Town of Breckenridge
Planning Commission Agenda

Tuesday, January 15, 2008
Breckenridge Council Chambers
150 Ski Hill Road

Planning Commission Staff Report

- Project Manager:** Chris Neubecker, AICP
- Date:** January 10, 2008 (For meeting of January 15, 2008)
- Subject:** Shock Hill Lodge and Spa, Tract E (Class A, Final Hearing, PC#2007108)
Shock Hill Master Plan Modification

2 ARCHITECTURAL SITE PLAN - NOVEMBER 26, 2007
 SCALE 1/4\"/>

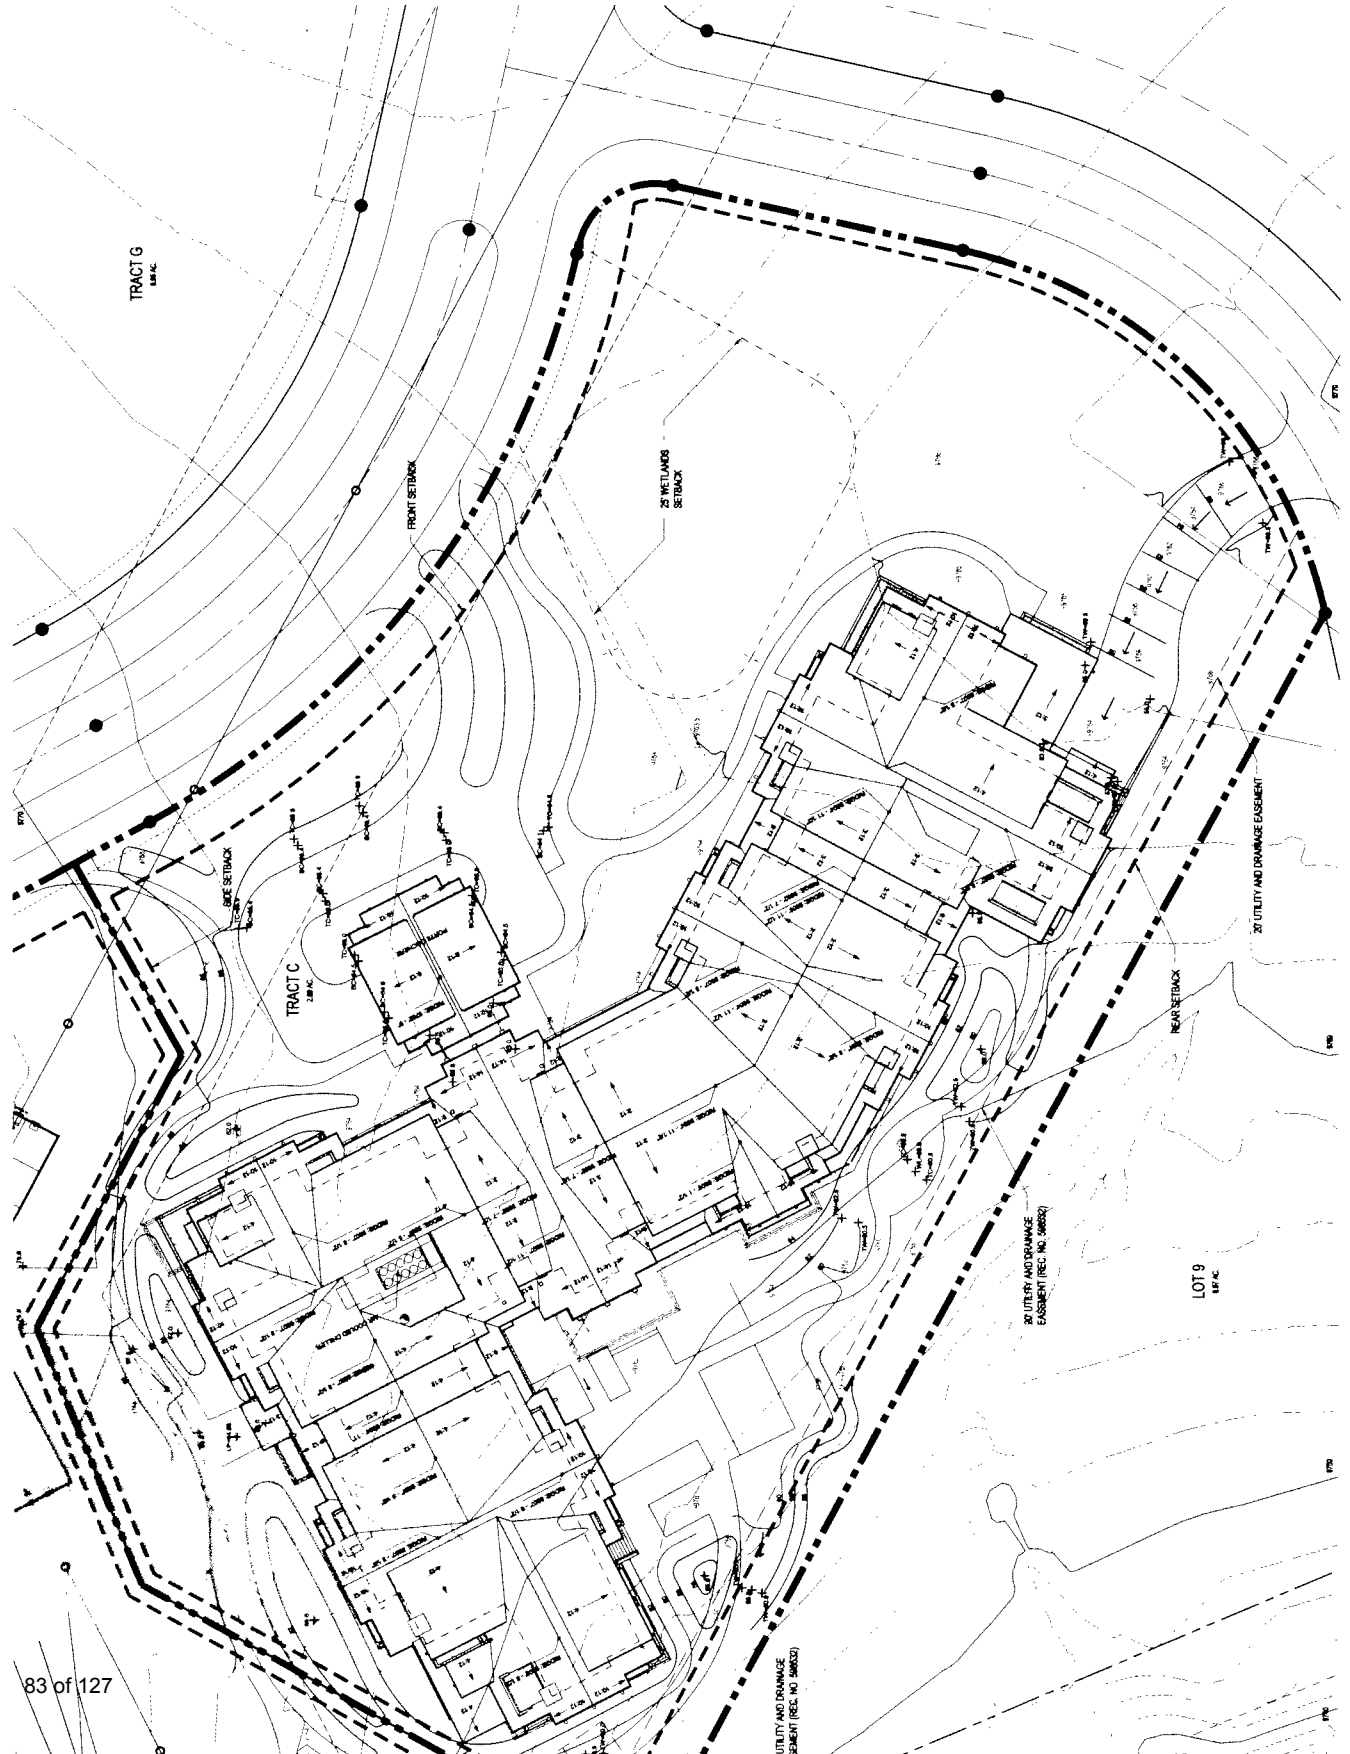
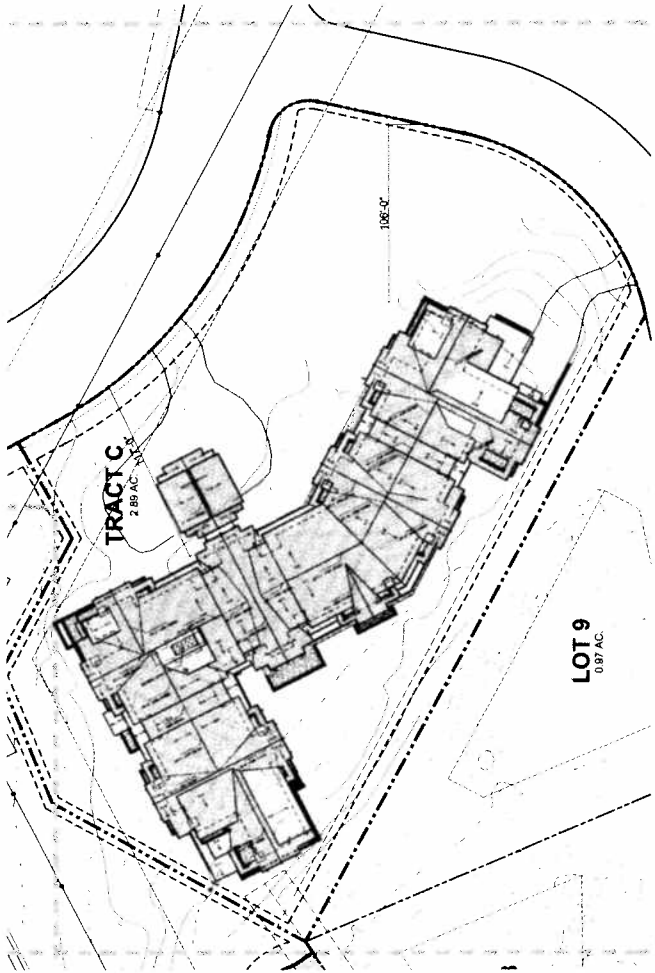
Placement Of Structures (9/A & 9/R): The location of the building is virtually identical to the location shown in the last submittal and to the site plan exhibit in the approved Development Agreement. The agreement indicates that the development plans need to be “substantially similar” to the exhibit site plan. As you can see from the site plan submitted for the Development Agreement (Sheet A1.11), the building was shown approximately 30’ from the right of way, and is now about 37’ away, except for the porte-cochere. The main body of the building was 164’ from the eastern property line, and is now 171’. Most importantly, the rear setback (from Cucumber Gulch) was 312’ in the agreement, and is now 312’.

SHEET NUMBER
A1.11

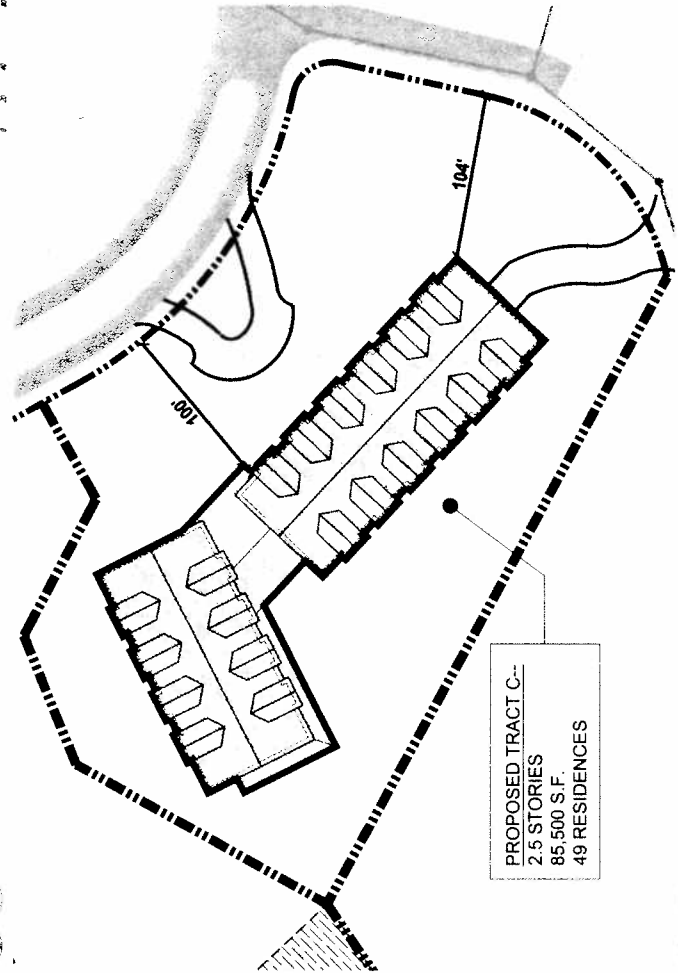
Site Plan: No significant changes are proposed to the site plan. The footprint location now substantially matches the exhibit in the Development Agreement, and is exactly the same at the rear of the building, which is 312' from the Gulch. (See Sheet A1.11)

A1.11). The Commission will need to agree that this plan is substantially similar to the site plan exhibit in the approved Development Agreement in order to approve this project.
